**GLADSTONE PLANNING COMMISSION AGENDA  
GLADSTONE CITY HALL, 525 PORTLAND AVENUE, GLADSTONE**

## **STAFF REPORT: DESIGN REVIEW**

**Application No.:** Z0425-19-D;

**Project Description:** Construction of a new 2,124 sq. foot building on a vacant lot adjacent to an existing residence located at 420 W. Arlington. The property owners are utilizing space on the adjacent non-conforming residential lot for parking.

SOUTH EXTERIOR ELEVATION 1  
1/4" = 1'-0"

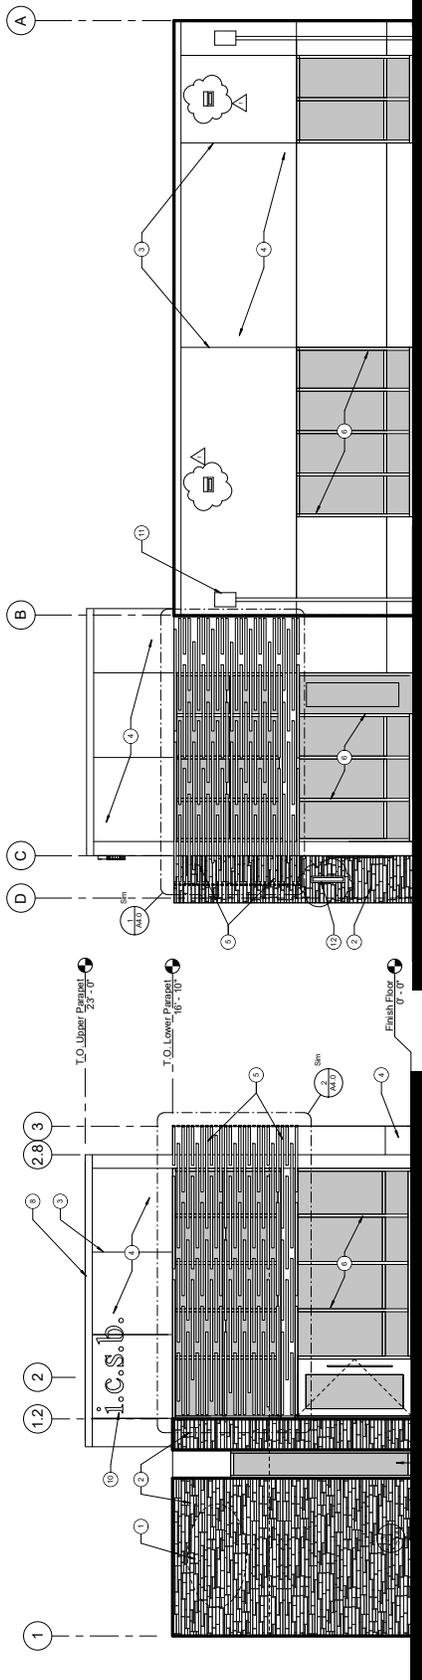
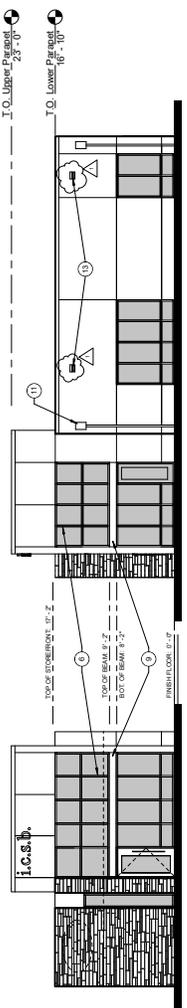
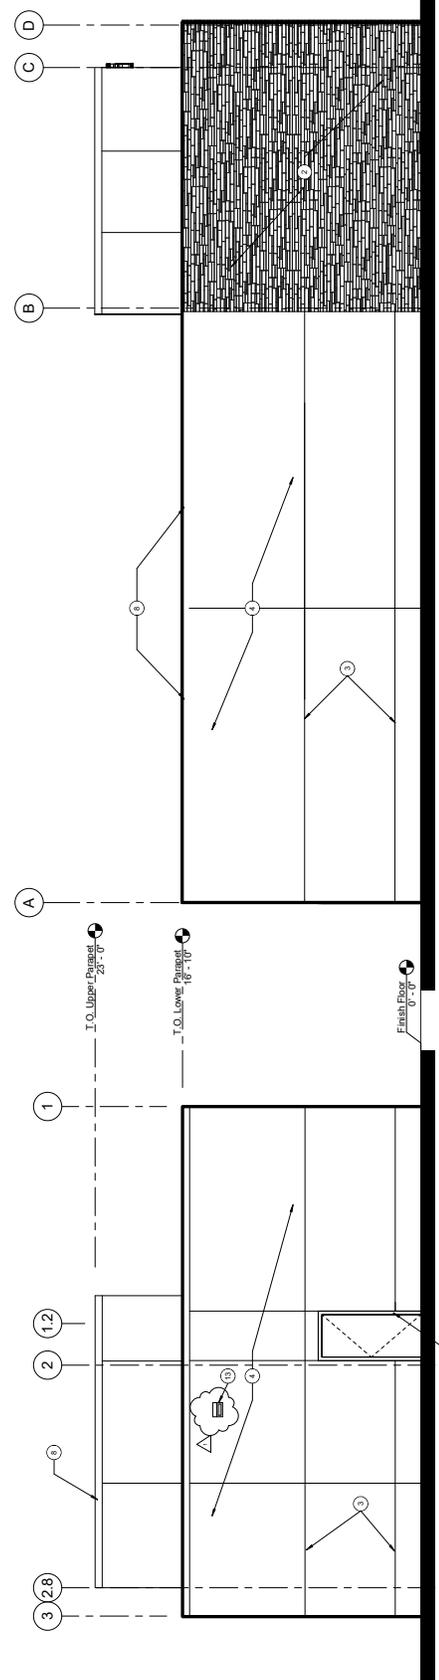
- o Windows - On A2.0 are the #6 "aluminum storefront assembly" windows? **Yes, these are window. Please see note modification in the plans ON**

sheet A2.D. What is the coverage area of the proposed windows? The proposed window coverage on the North side of the building is approximately 45% and the window coverage for the East side of the building is approximately 33%.

**AS1.1**

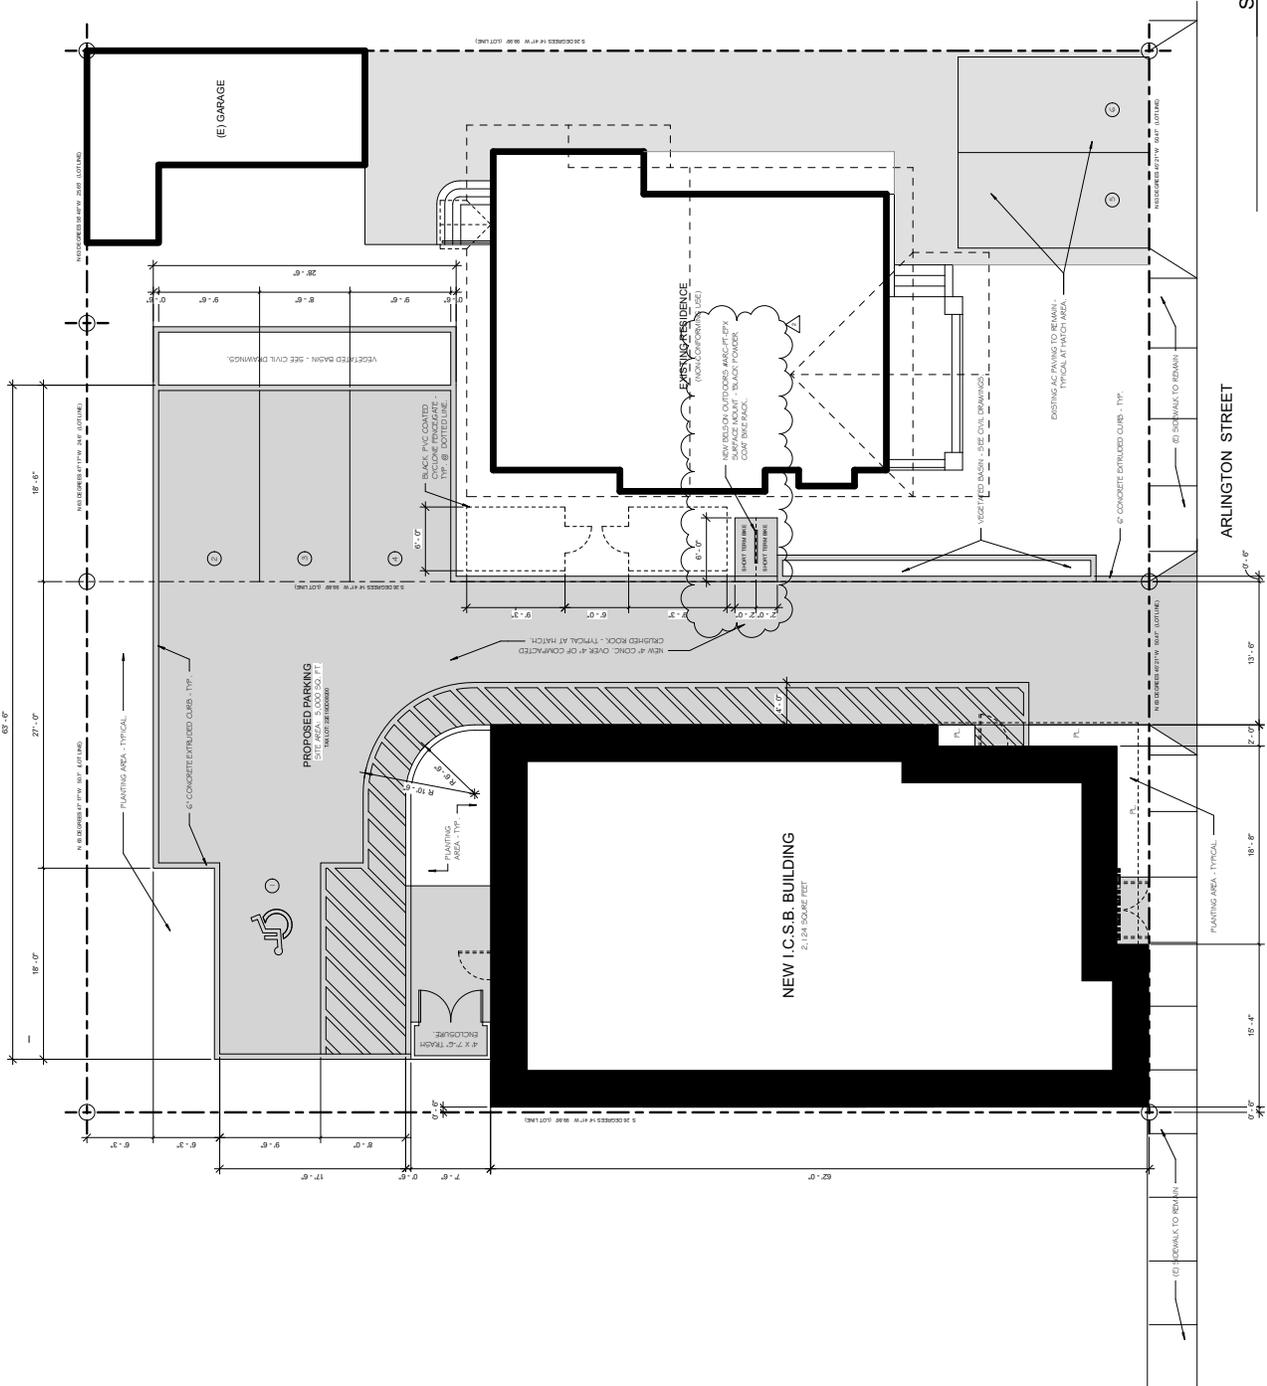
- o Lot lines – Neither AS1.1 nor C-1.0 label lot lines in the legend. The lot lines appear to be in the plans but without having them labeled it is hard to determine if they are in fact the lot lines. Could you please clearly label the lot lines? **Please see revised Site Plan Sheet AS1.1 for delineation of the lot lines.**

- o Bicycle Parking – Is required for new commercial developments per code Section 17.48.050. Is there a provision for the bicycle parking (minimum of 2 spaces)? Where will it be located? **Please see revised sheet AS1.1 for the addition of the bicycle parking.**
